STAFF REPORT

Project Title: Alamo Glen Trail 4-Lot Minor Subdivision and Rezoning

County File(s): # MS15-0002/RZ15-3229

DIMENSIONED SITE PLAN & SECTIONS
 "ALAMO GLEN" (MS 15-0002)
 20 ALAMO GLEN TRAIL, ALAMO, CA

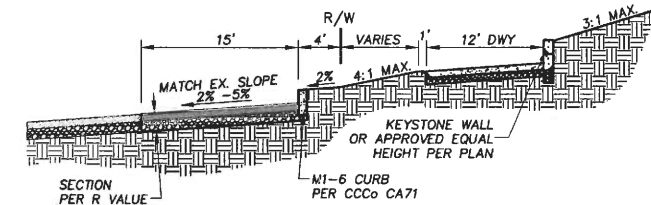
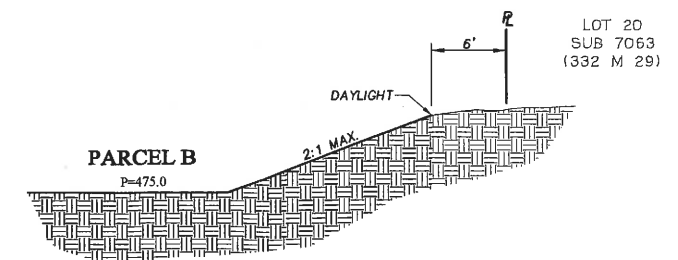
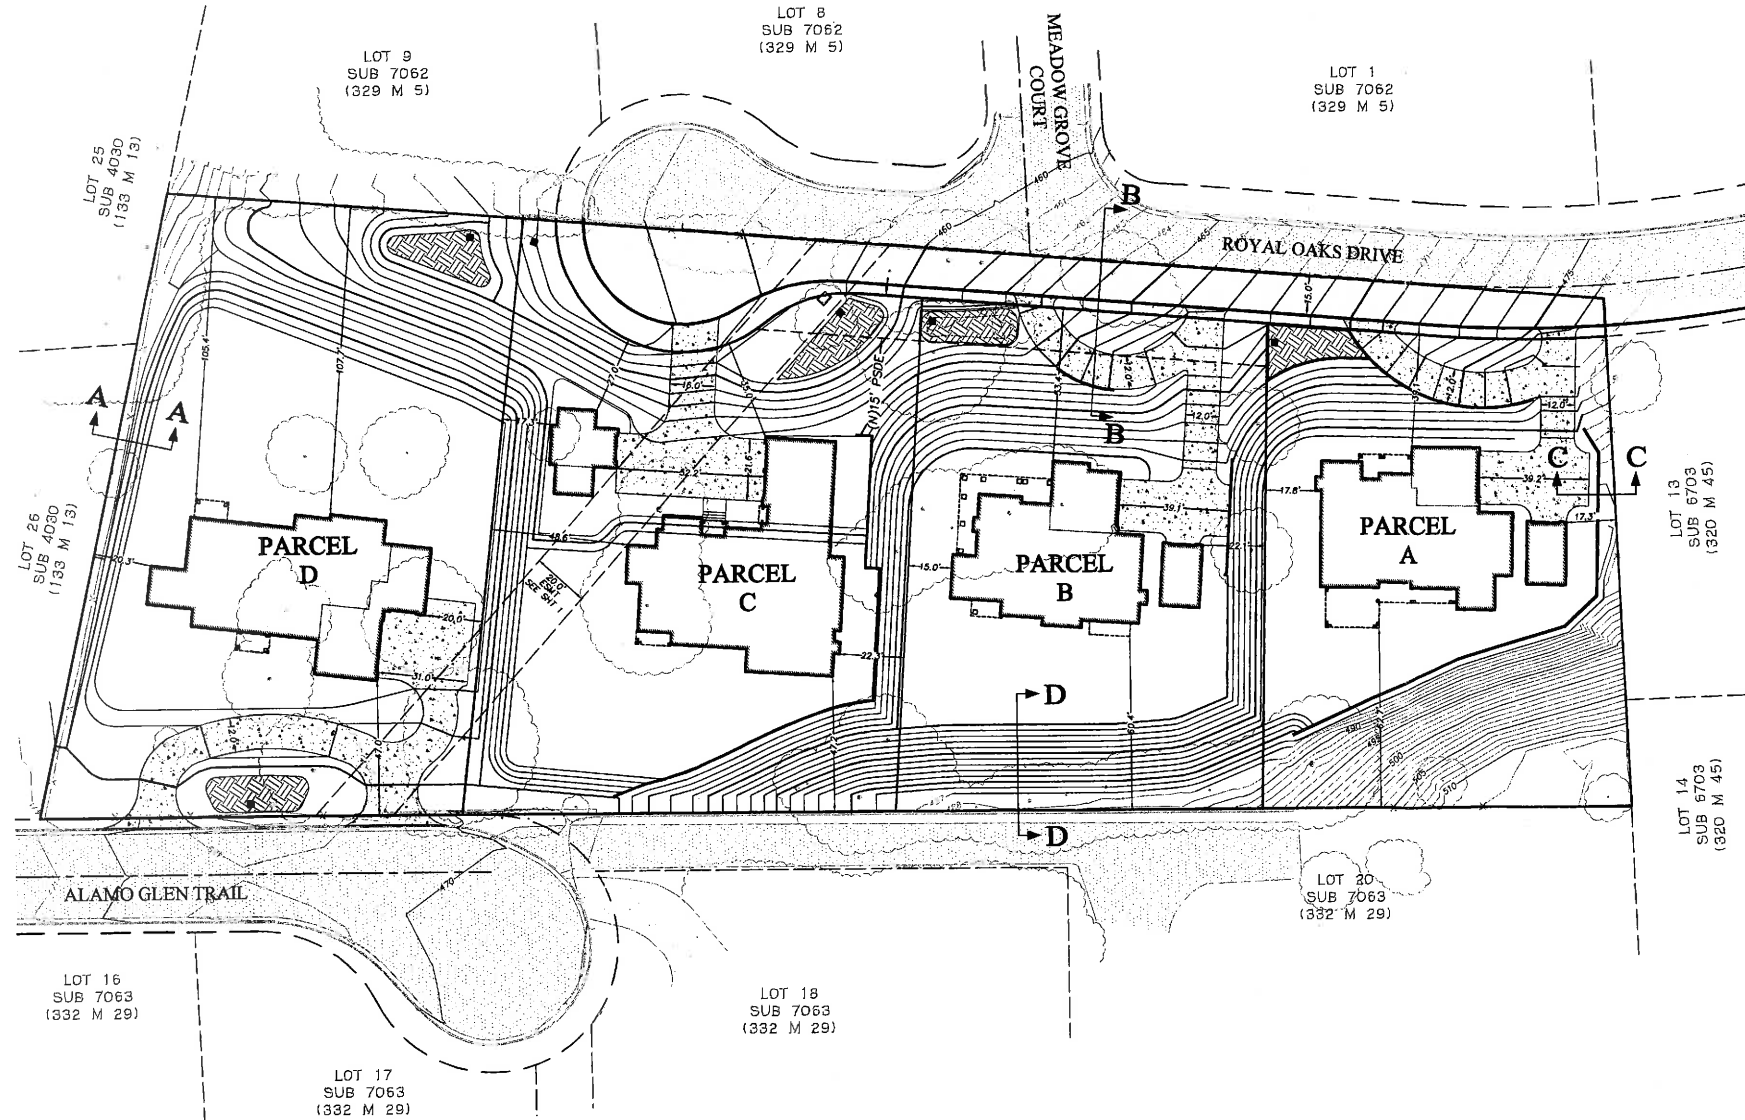
On Sheet 3, the arrows on the plan view notation for Sections B-B and D-D are facing the wrong direction relative to the section views shown. The arrows should be corrected.
